ADDENDUM NO. 1

**City of Los Banos
Final Kilometer Sewer Trunk Line Replacement Project**

March 14, 2025

SHEET C10

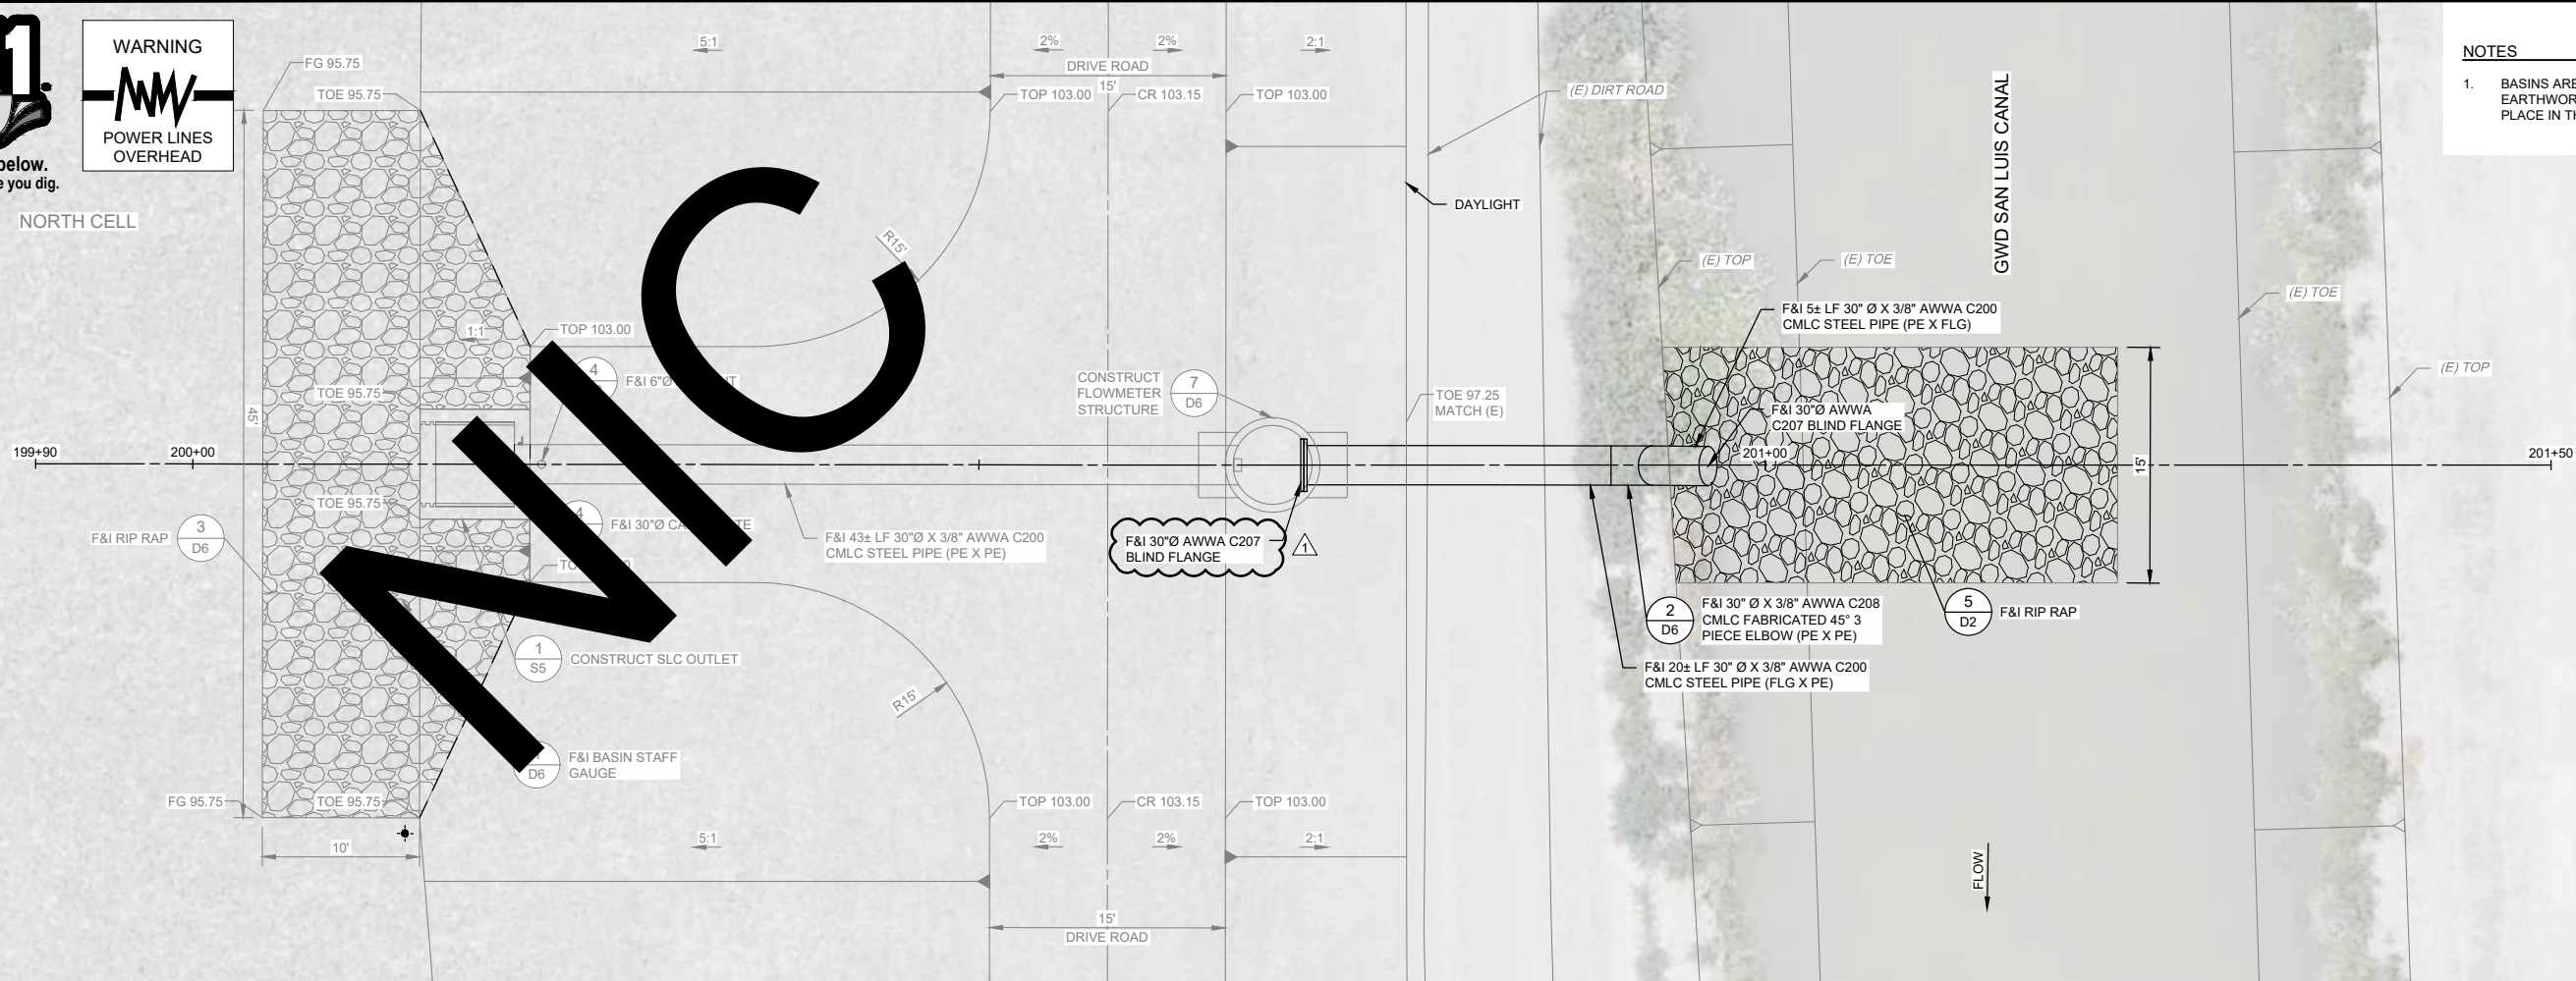
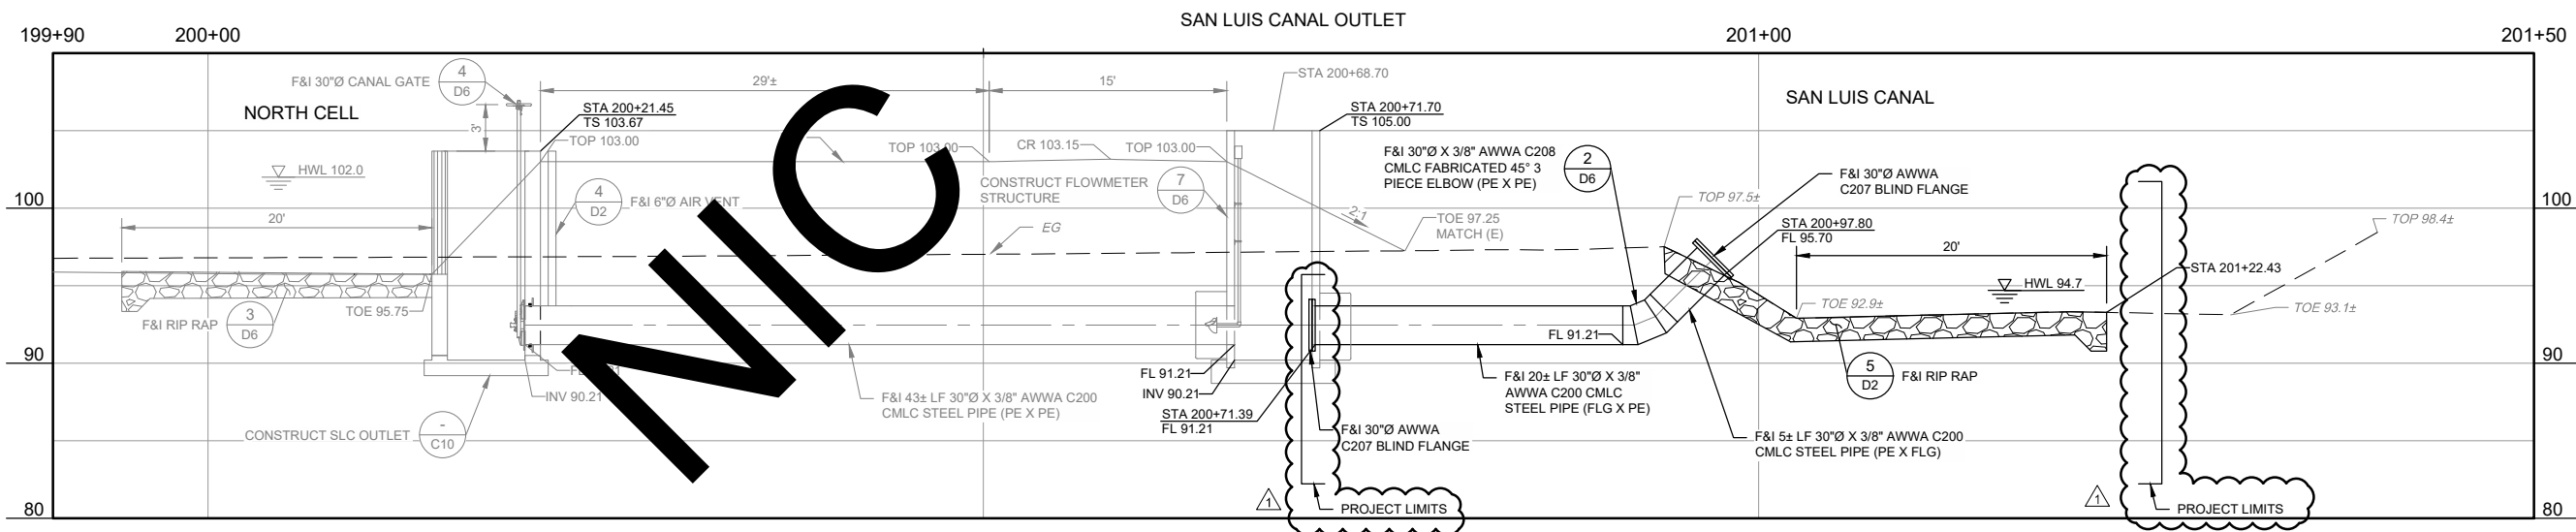
3. Plan sheets C9 and C10 show NIC. Is everything on these two plan sheets excluded from this contract?

The 30-inch x 3/8" Wall AWWA C200 CMLC Steel Pipe, Bends, Blind Flanges & Appurtenances, and Rip Rap with Geotextile Fabric referenced within the plan set in Sheet C10 – San Luis Canal Outlet are included in this contract. Refer to Bid Item #11 in Section 24 of the Special Provisions within the Project Specifications.

DRAFTED BY: PD, CAJ
CHECKED BY: KK, GMH
DATE: 03/05/2025
JOB NO: 350123011
PROJECT NO: CLB 2023-019
PHASE:
ORIGINAL SCALE SHOWN IS ONE INCH. ADJUST SCALE FOR REDUCED OR ENLARGED PLANS.
SHEET D1

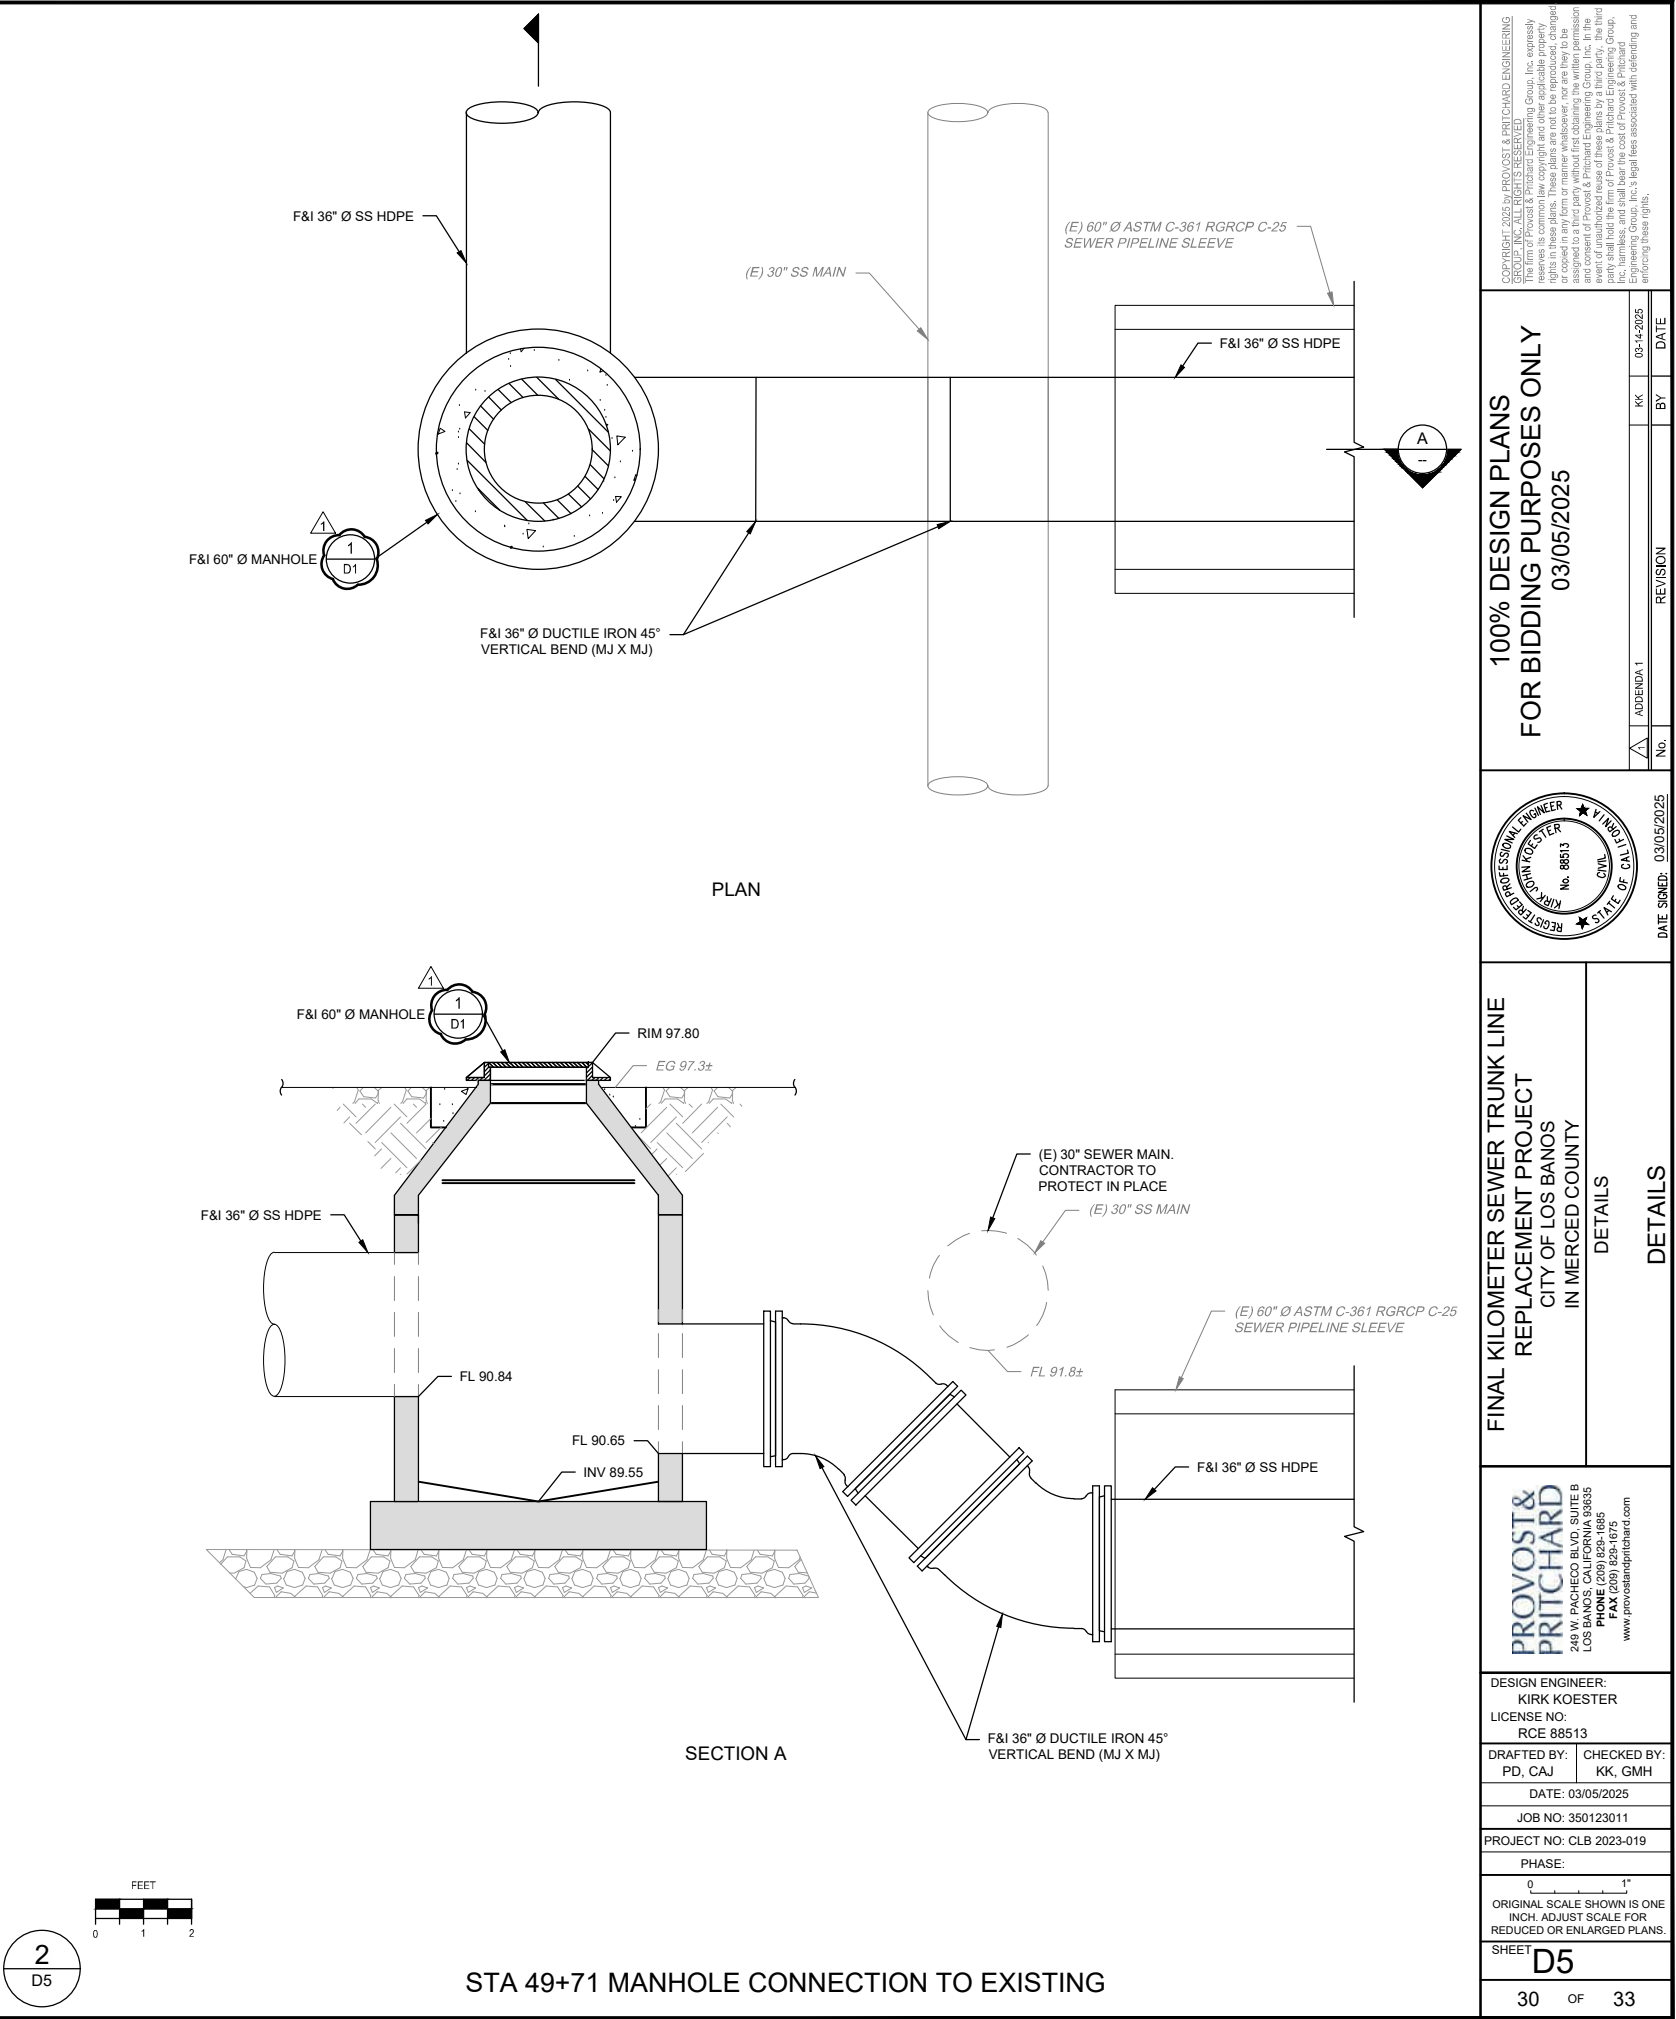
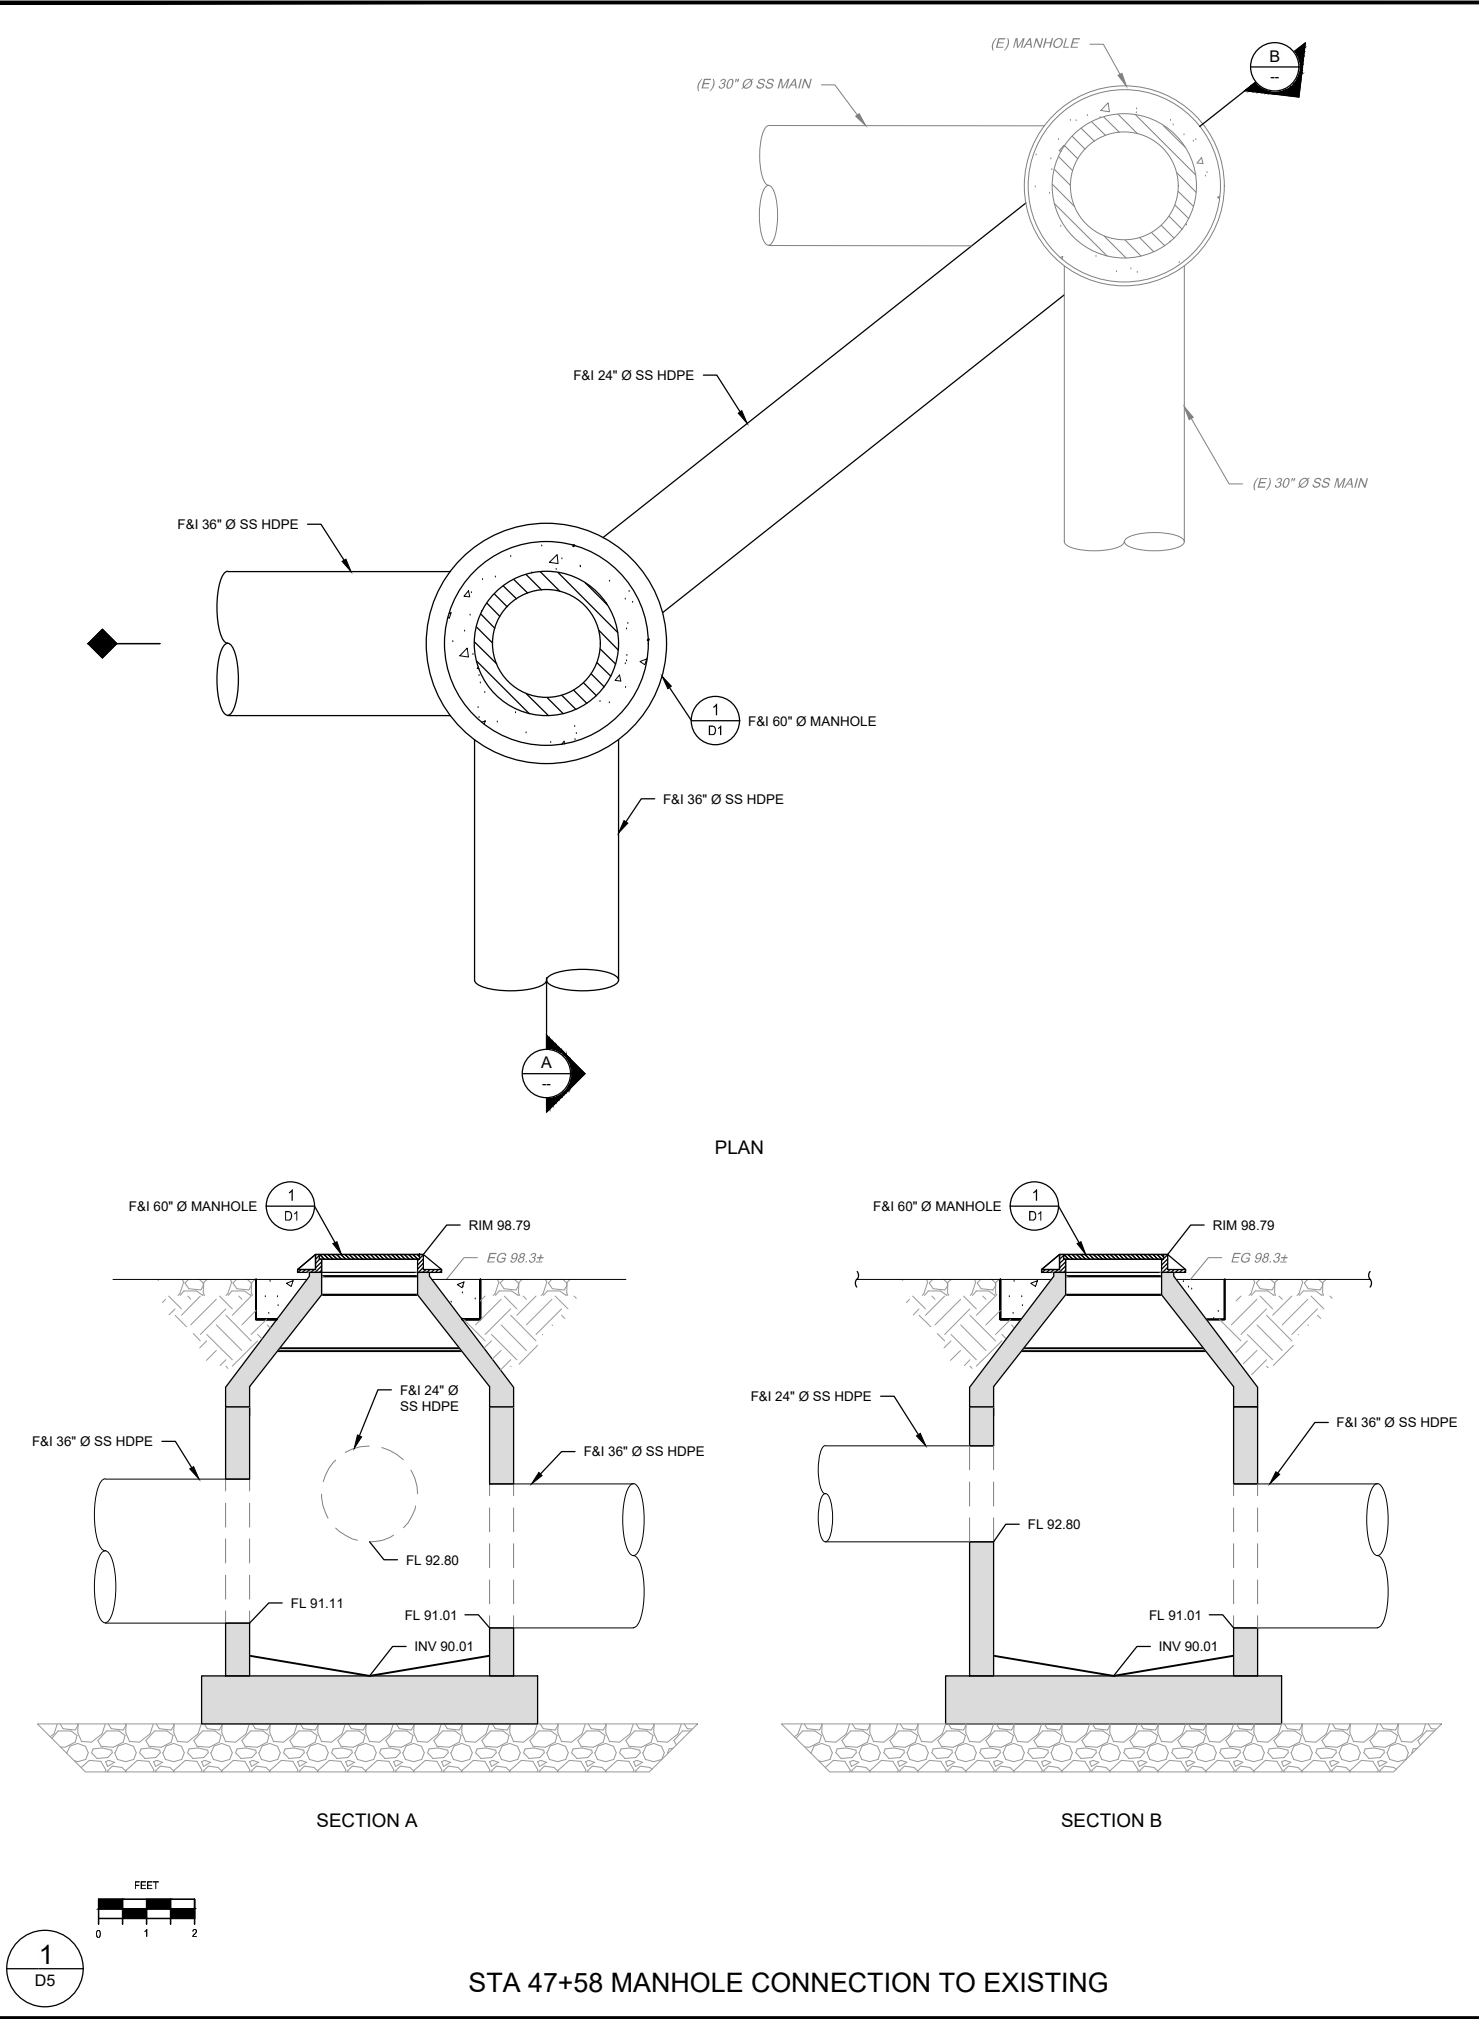
Section 31 23 17 2.4.C.1. The Bedding and Backfill requirements shall be revised as follows:

Material property requirements for bedding and backfilling of manholes shall adhere Detail 7 in Sheet D1 – City of Los Banos Standards. Bedding material property shall adhere to Class 1 Bedding. Backfill material property shall adhere to Class 1 Backfill.

2. **Manhole Bedding: Bedding material properties shall adhere Detail 7 in Sheet D1 – City of Los Banos Standards. Bedding material property shall adhere to Class 1 Bedding. shall meet Class 1 Bedding material properties.**

4. **Manhole Backfill: Backfill material properties shall adhere Detail 7 in Sheet D1 – City of Los Banos Standards. Bedding material property shall adhere to Class 1 Bedding. shall meet Class 1 Bedding material properties.**

- A. **As specified in Detail 7 – Sewer Manhole Backfill in Sheet D1 within the Project Plans.**
